RE: U.S. Bureau of Reclamation's Draft Environmental Impact Statement for Post-2026 Operational Guidelines and Strategies for Lake Powell and Lake Mead

The Grand Canyon Trust ("Trust") submits this letter to provide comments on the U.S. Bureau of Reclamation's *Draft Environmental Impact Statement for Post-2026 Operational Guidelines and Strategies for Lake Powell and Lake Mead* ("Draft EIS"). Reclamation proposes to adopt new guidelines and management strategies for the coordinated operations of Lake Powell and Lake Mead to replace current guidelines and agreements that expire in 2026. Reclamation acknowledges that careful management of the Colorado River is important because it is "the foundation for diverse resources across a large geographic region and faces exceptional challenges from prolonged drought and future uncertainty."¹ The agency further recognizes that the "actions taken over the past two decades have not been sufficiently robust to prevent continued decline of the reservoirs" and that new guidelines must "address the continued loss of storage and the potential for increasing severity of drought and low runoff conditions."²

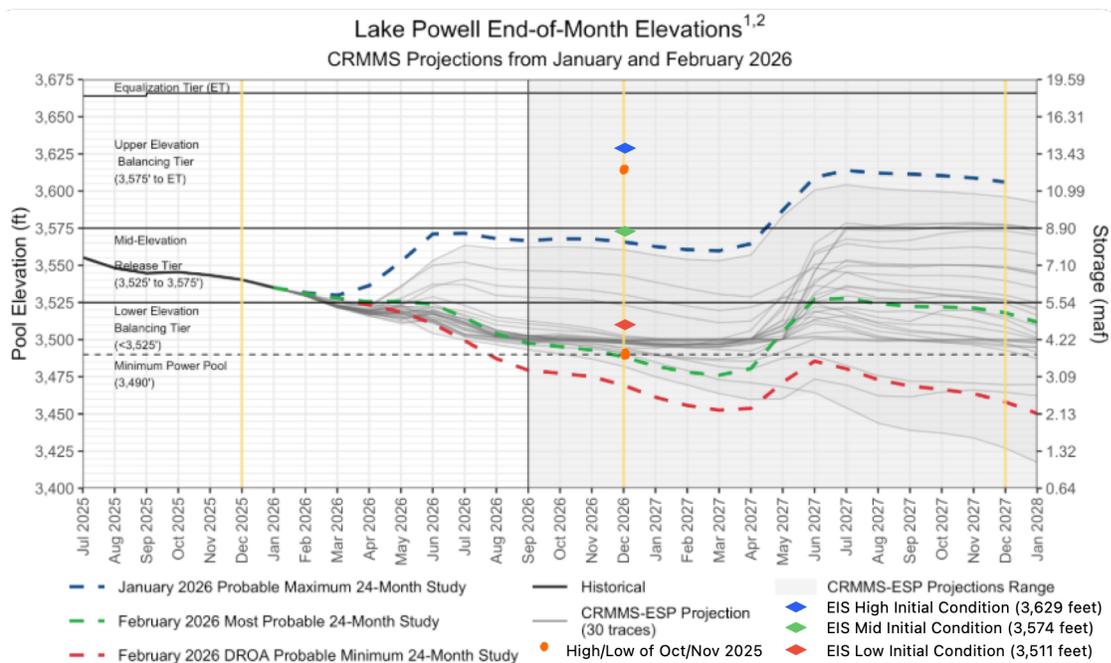
The agency determined initial reservoir conditions for its modeling nearly two years ago using the November 2024 CRMMS-ESP.¹⁰ Figure G-1 shows the December 2026 high, mid, and low initial conditions (blue, green, and red stars) selected for the Draft EIS analysis and compares them with the October and November 2025 projections.¹¹

The November 2025 CRMMS-ESP ensemble shows a broad range of potential end-of-2026 elevations for Lake Powell, spanning approximately 3,490.21 to 3,615.40 feet. The DEIS Low and Mid initial conditions fall well within the ensemble, while the High initial condition is approximately 20 feet above the upper bound of the current projection range. The high bias in initial conditions is consistent with expectations given that the DEIS

initial conditions were based on the November 2024 CRMMSESP ensemble, prior to the below-average WY 2025 runoff [].¹²

The agency concludes that “despite deterioration in system conditions since the DEIS initial conditions were finalized, the DEIS initial conditions **continue to span the range of plausible end-of-2026 system states** represented in the most recent CRMMS-ESP projections.”¹³ That conclusion, however, is no longer viable given the most recent 24-month projections from January and February 2026.¹⁴

a) *Initial reservoir conditions must be updated in the Final EIS to reflect current conditions and to accurately evaluate the alternatives and effects on system resources.*

Reclamation overestimates the projected reservoir conditions at the start of the new guidelines in December 2026. Conditions in the basin have deteriorated significantly since the November 2024 modeling, leaving two of the three initial conditions completely outside and above the range currently projected to exist in December of 2026. This failure skews every analysis in the EIS wet, thus rendering the analysis deficient.

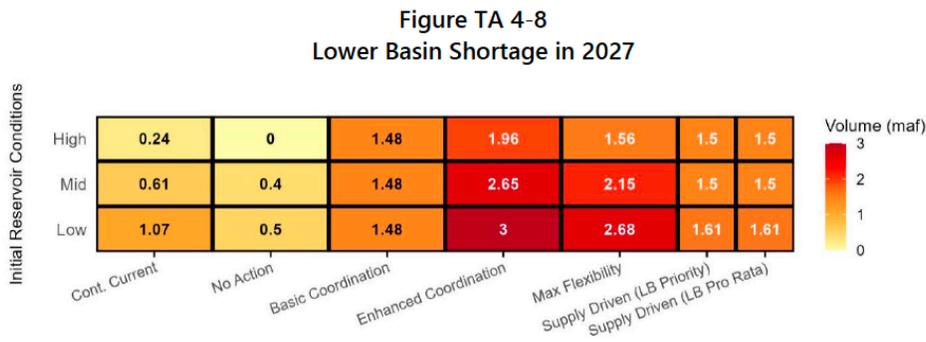
These new projections are considerably lower than those made in October and November 2025.¹⁵ The figure below is Reclamation’s 2-Year Probabilistic Projections from January and February 2026. The Trust has added for demonstrative purposes three diamonds showing the high (blue), mid (green), and low (red) initial conditions, which are the same elevations identified in the Draft EIS, Figure G-1, Appendix G. Further, the Trust included two orange dots showing the Oct/Nov 2025 projected high and low range of traces from Figure G-1, reproduced above.¹⁶

The January/February 2026 high, mid, and low elevations for December 2026 are 3,565, 3,488, and 3,469 feet, respectively.¹⁷ These elevations are 64, 86, and 42 feet below the high, mid, and low initial conditions selected as the foundation of the modeling in the Draft EIS.

Further, the selected high and mid initial reservoir conditions of 3,629 feet and 3,574 feet are above the January/February 2026 high end of the range (3,565 feet). While the low initial condition (3,511 feet) still falls within the November 2025 range, it is 23 feet above the projected mid condition for January/February 2026 and 42 feet above the low condition. Thus, the November 2024 initial conditions used as the foundation for the modeling in the Draft EIS is no longer adequate to represent the starting point for the new guidelines. The reservoir levels throughout the Draft EIS were overestimated, which resulted in a flawed analysis. Reclamation must update these initial conditions based on the January and February 2026 24-month study or subsequent projections released before the agency conducts the analysis for the Final EIS.

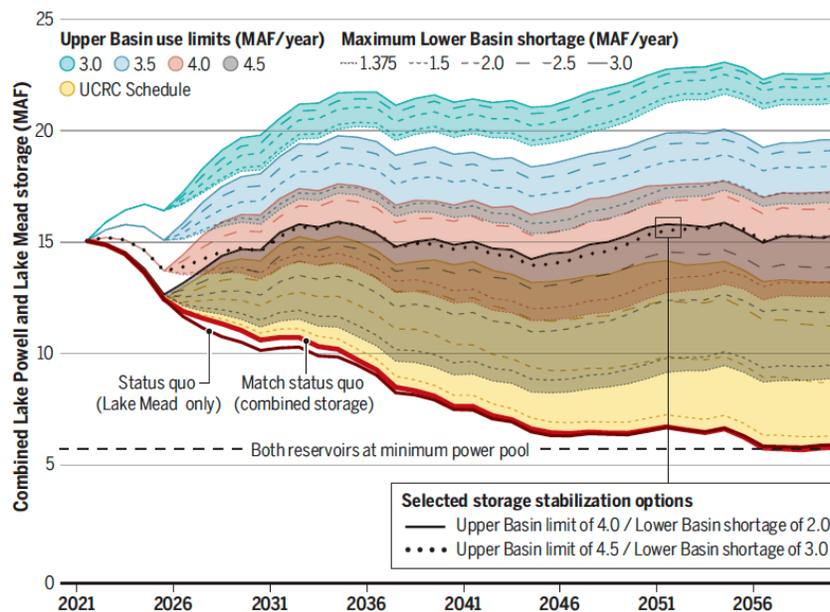
Despite this analysis, Reclamation has not gone far enough to analyze the role Upper Basin reductions play in stabilizing reservoir storage in the Colorado River system. Even if solutions can keep reservoirs above critical elevations in the near-term (and there is little evidence that they will), the basin's water supply is predicted to continue to constrict 20-30% by midcentury and 35-50% at the end of the century.³¹

Reclamation's analysis fails to weigh the tradeoffs of Upper Basin expansion of use and the Lower Basin shortages on a system-wide basis. Wheeler et al. (2022) provides a figure that allows comparison of the Upper Basin consumptive use that could be paired with Lower Basin shortages to stabilize Lake Powell and Lake Mead above critical elevations.³²

This analysis is helpful to understand the role of Upper Basin contributions (voluntary or otherwise) to sustaining the health and stability of the Colorado River Basin. Net water demand reductions in the basin (whether taken as a shortage in the Lower Basin or contribution by the Upper Basin) is what will help balance supply and demand in a way that can protect reservoir elevations and make water available for system resources. We believe Reclamation should consider a similar analysis and/or should carry forward its sensitivity analysis into an alternative in the Final EIS. One strategy is to temporarily hold Upper Basin use to a certain level at times when higher Lower Basin shortages are required and when necessary to rebuild reservoir storage above critical elevations.
